TN05 – LLFA Comment Response (4)

Site: Land East of Mousdell Close, Ashington
Prepared by: Phil Allen MCIWEM C.WEM
Approved by: Jason Morgans
Date: 9 February 2026

**DC/25/1327 Land East of Mousdell Close Rectory Lane Ashington RH20 3GS
Erection of 74 dwellings with associated access, parking, and landscaping.**

worksafe
 HSA
 THE SURVEY ASSOCIATION
 Constructionline

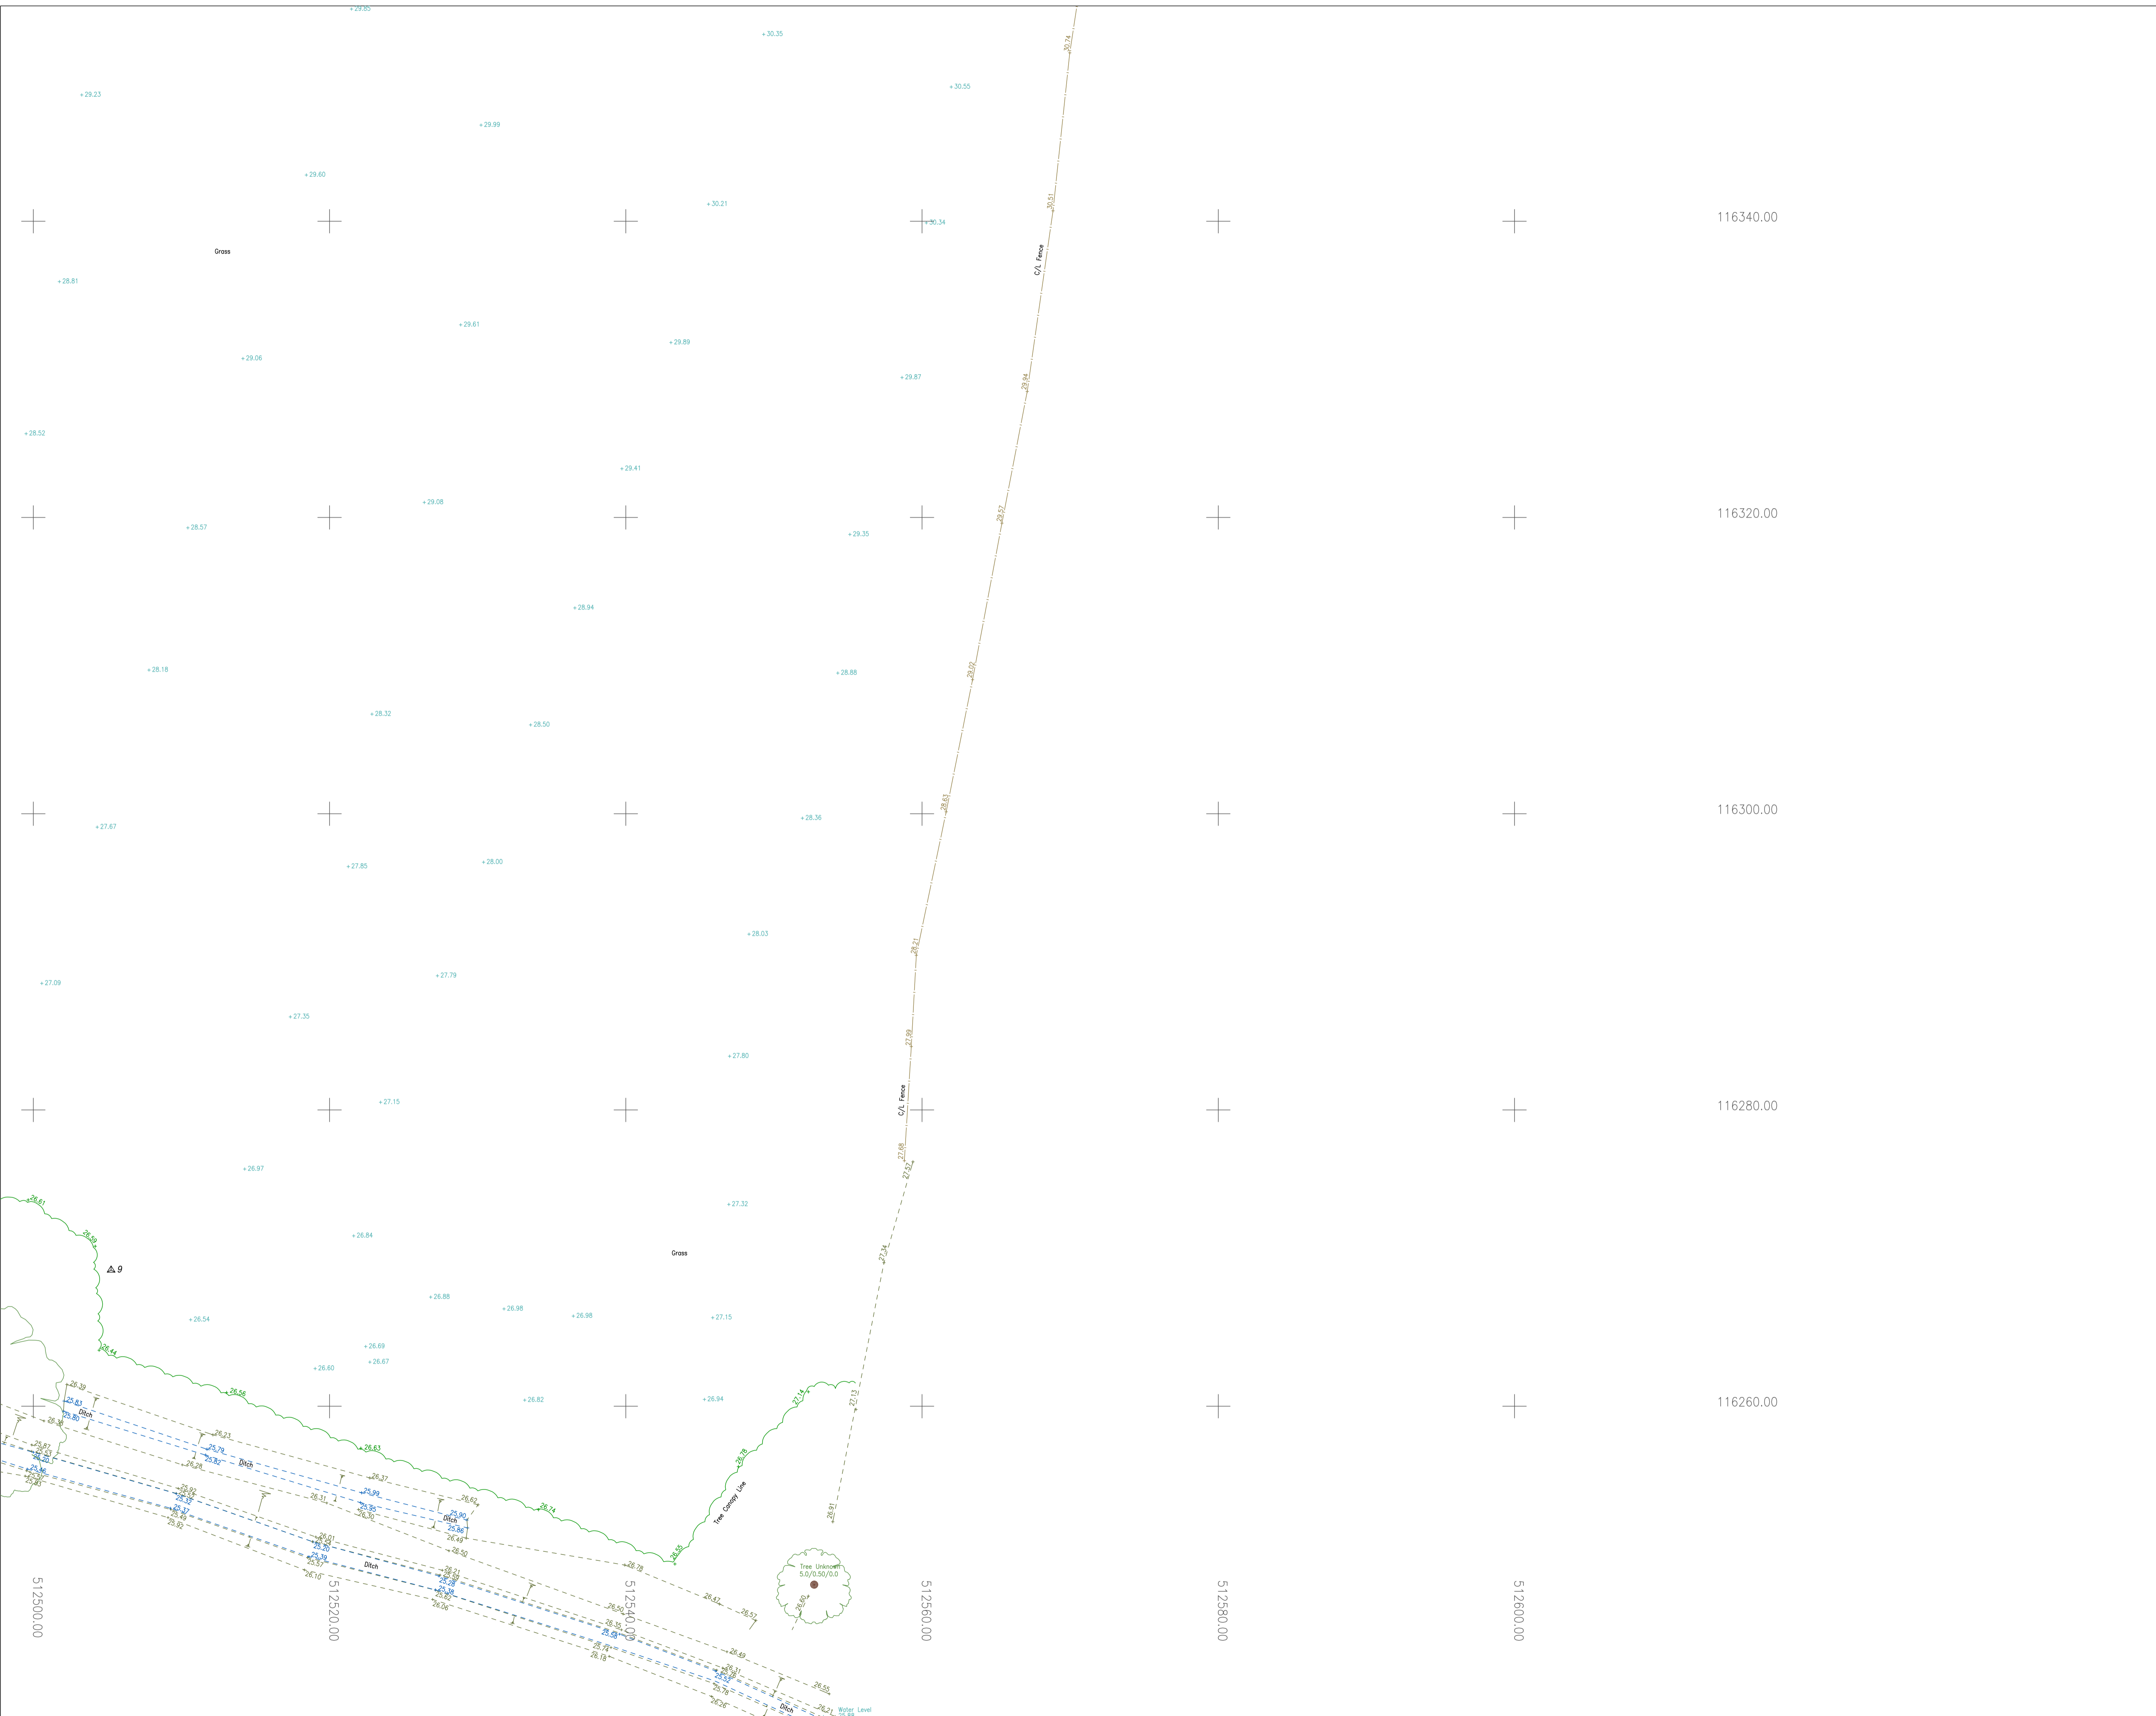
- a) The current drainage layout only shows an outfall and not the receiving watercourse. An invert level for that outfall is given (25.80), but no existing silt levels, hard-bed levels, or bank-top levels are provided for the receiving watercourse, so it is unclear if this is a viable point of discharge. As I have previously stated the viability of the SuDS scheme is wholly reliant on there being a suitable discharge location. Therefore, I would like to repeat my request for both the path and levels of the receiving watercourse to be detailed on the drainage layout (to enable me to appraise the suitability/viability of the discharge point).

- b) I also need to understand the condition of the section of the receiving watercourse where the developer/landowner has riparian responsibilities (particularly downstream of the proposed SuDS outfall). This is to ensure the discharge can be appropriately conveyed on downstream (rather than escaping the confines of the watercourse, due to blockages, and causing flooding on third party land). This is of particular concern given the photographs, submitted by others, which suggest that this watercourse may be significantly obstructed. (Note: At no point have I suggested that the developer is required to undertake works to clear sections of this watercourse beyond their riparian responsibilities. I assume the images in question relate to the section of this watercourse under the developer/landowner's control, if they do not; then developer would not be required remediate those problems. Had the current silt levels, hard-bed levels, and bank levels of the receiving watercourse, where it abuts the site, been included on the proposed drainage layout the current situation, and any need for maintenance interventions, would have been much clearer).

- 2.1 A survey of the receiving watercourse has been carried out, and this can be seen in [Appendix B](#). This survey shows the silted levels, hard bed levels and bank top levels of the receiving watercourse.

- 2.2 This survey shows that the silted and hard-bed levels are below that of the original outfall specified in the drainage strategy (25.80mAOD), thus the survey has demonstrated that the watercourse is viable for a gravity outfall. The survey also shows that there is a consistent gradient across the watercourse bed levels and that there are no blockages.

Updated Drainage Strategy Including Extended Topographic Survey

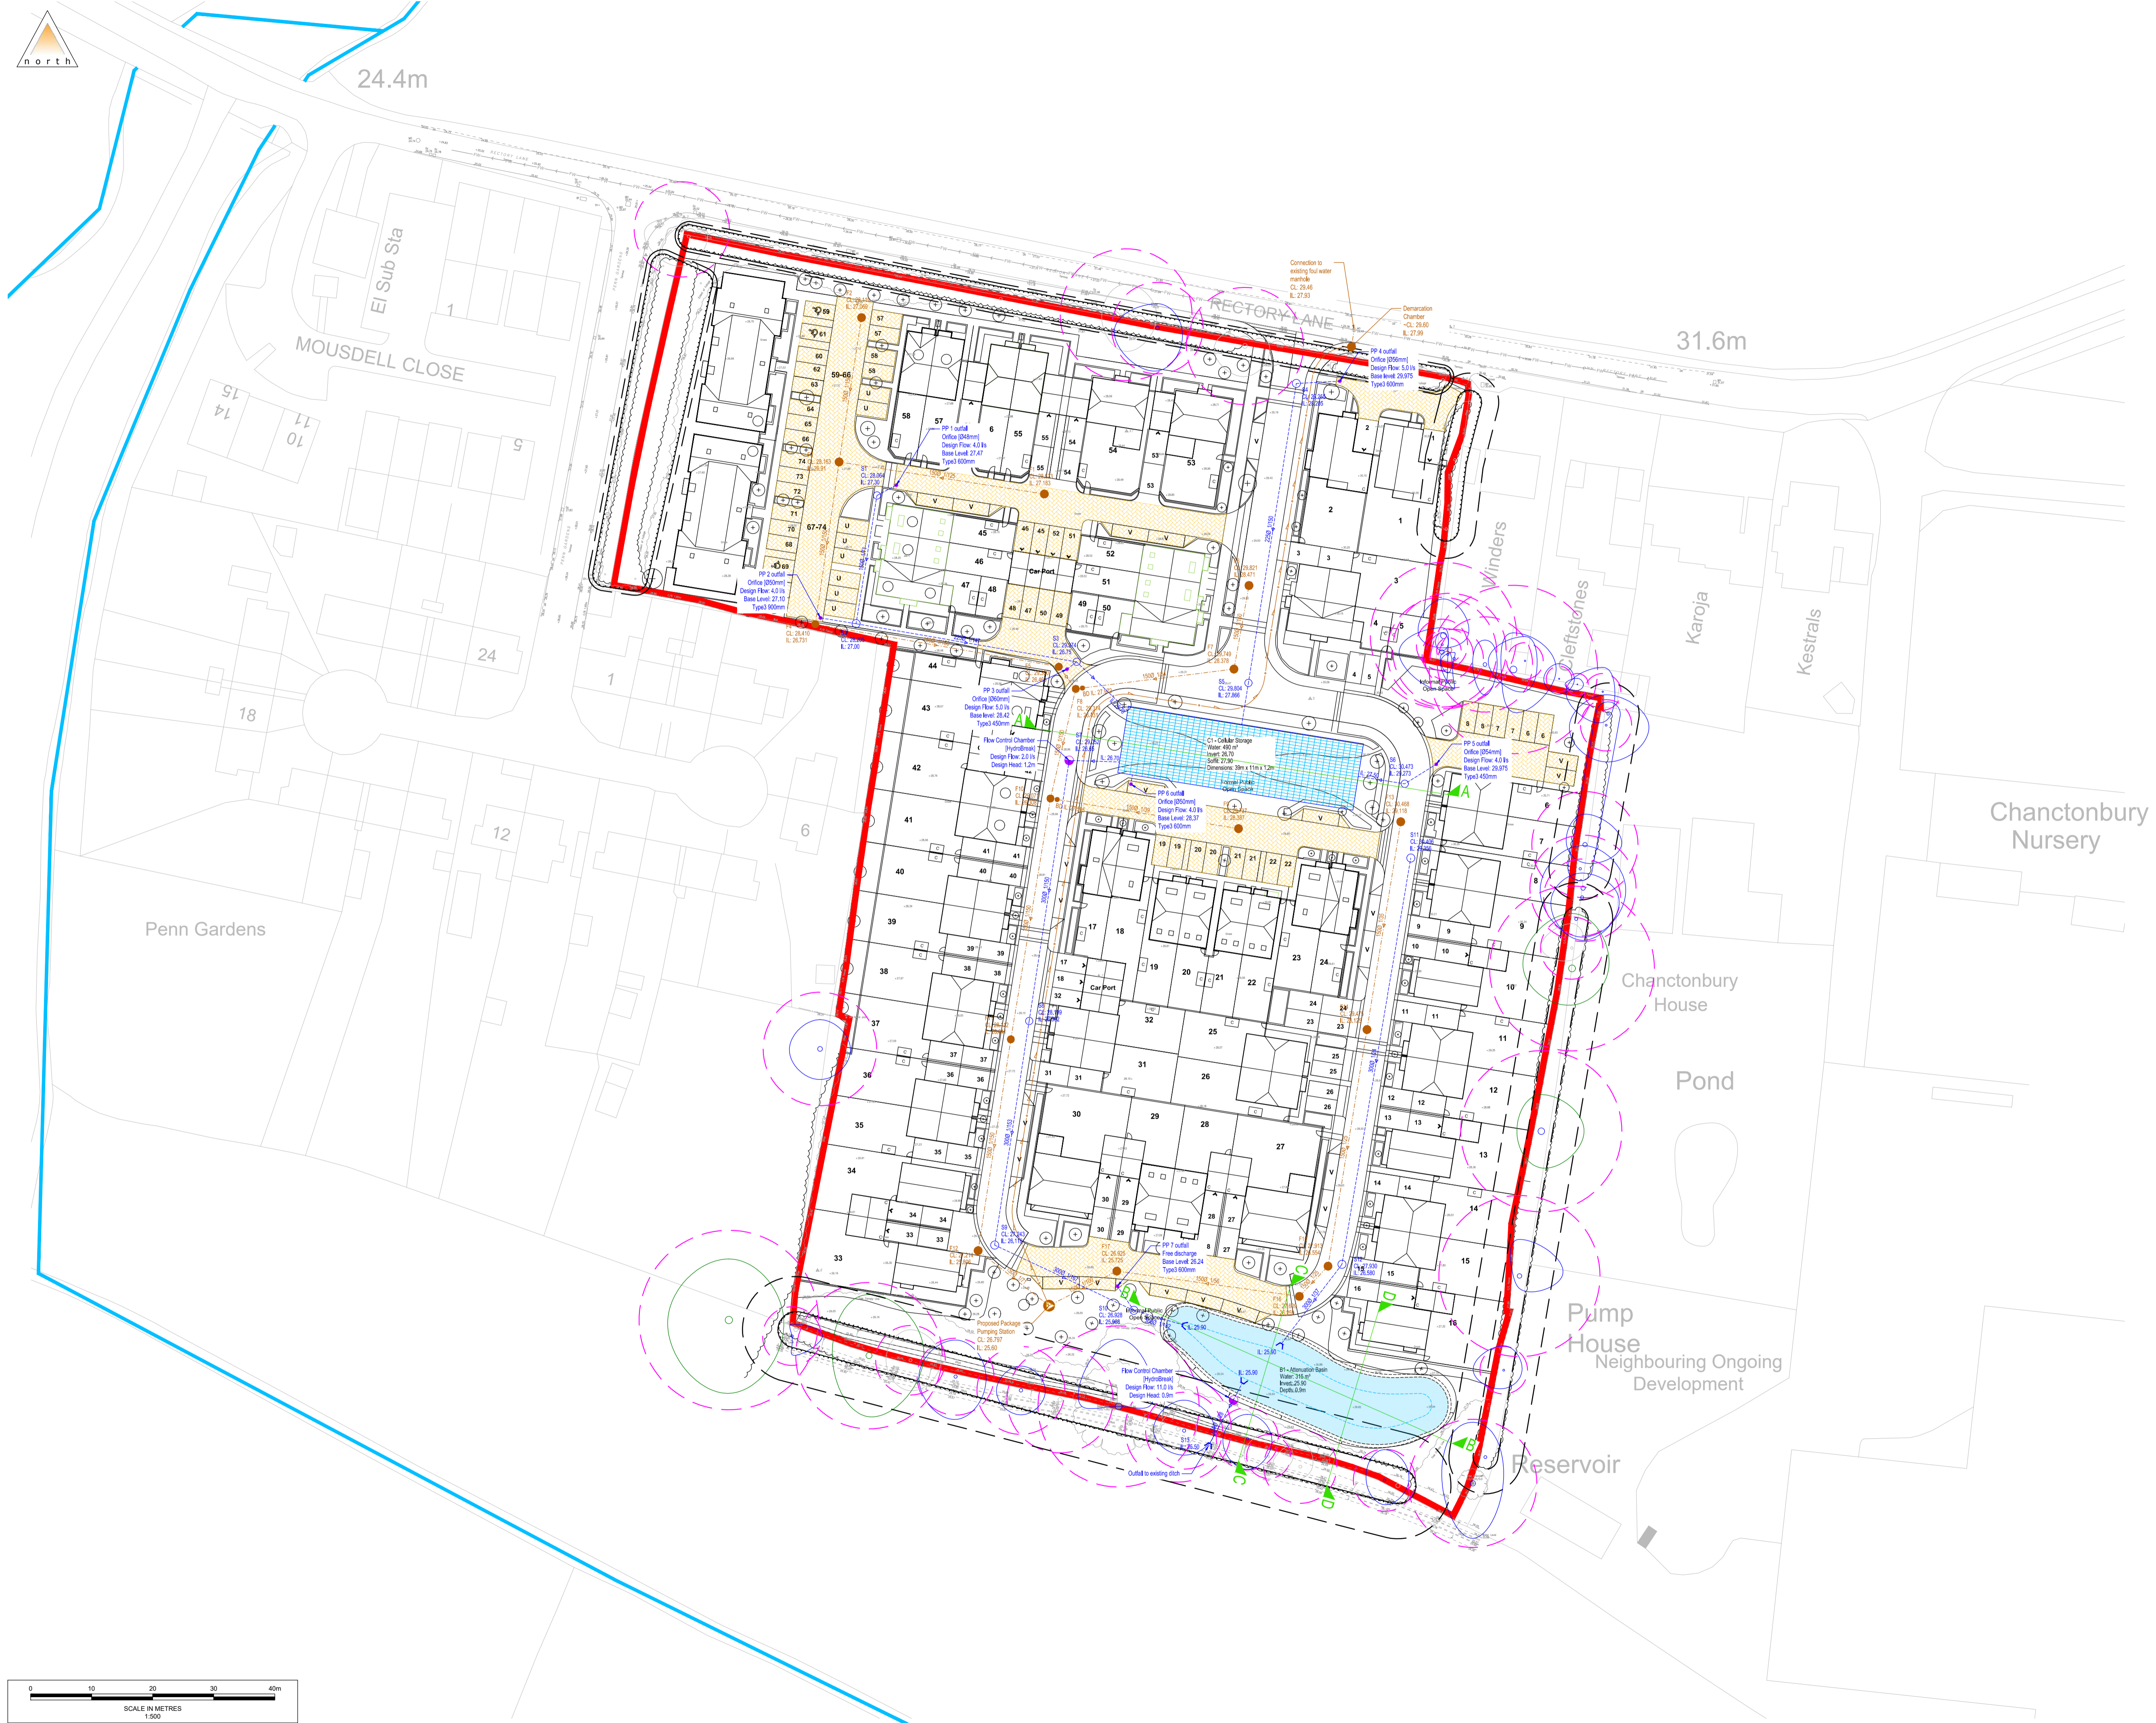
1. A survey and details of the existing silted and hard-bed levels of the receiving watercourse, including bank-top levels and for these to be included on the drainage layout.

2. The LLFA want a note added to the drainage layout confirming that any routine maintenance will be carried out to ensure the receiving watercourse is in a suitable condition to receive surface water discharge from the site.

- c) I have previously requested that a note be added to the drainage layout confirming that any routine maintenance (in the form of removal of debris, de-siltation and re-grading) necessary to ensure the receiving watercourse is in a suitable condition to receive the discharge from the site, will be undertaken. No such note has been added; therefore, I still have concerns that the discharge from the development's SuDS could increase flood risk elsewhere, if it is able to escape the confines of the receiving watercourse. (Again, for clarity, this would only apply to the sections of watercourse where the developer/landowner has riparian responsibilities).

- 2.3 The outputs of the survey have been added to the drainage strategy ([Appendix C](#)) and, because the level of the outfall is lower than previously specified, the InfoDrainage hydraulic calculations have been updated so that they fully align with the drainage layout (although the lowered outfall has made no change to the overall function of the system). The updated InfoDrainage results are in [Appendix D](#).

- 2.5 A note has been added to the drawing (Note 7) that states "*The site will uphold its riparian rights and responsibilities and be in accordance with the statutory requirements of the Land Drainage Act (1991)*". This fully captures the LLFA's request that routine maintenance should be carried out to ensure the receiving watercourse is in a suitable condition to receive surface water discharge from the site because, as highlighted in our previous Technical Note, the legally binding responsibilities in the Land Drainage Act (1991) are clear, and they mandate riparian owners to:
- Keep the bed and banks clear of debris, vegetation, or any form of obstruction,
 - Maintain any structures (e.g. culverts, weirs) within the watercourse,

- Manholes situated within areas accessible to motor vehicles are to be fitted with suitable strength covers and frames.
 - The site will uphold its riparian rights and responsibilities and be in accordance with the statutory requirements of the Land Drainage Act (1991)
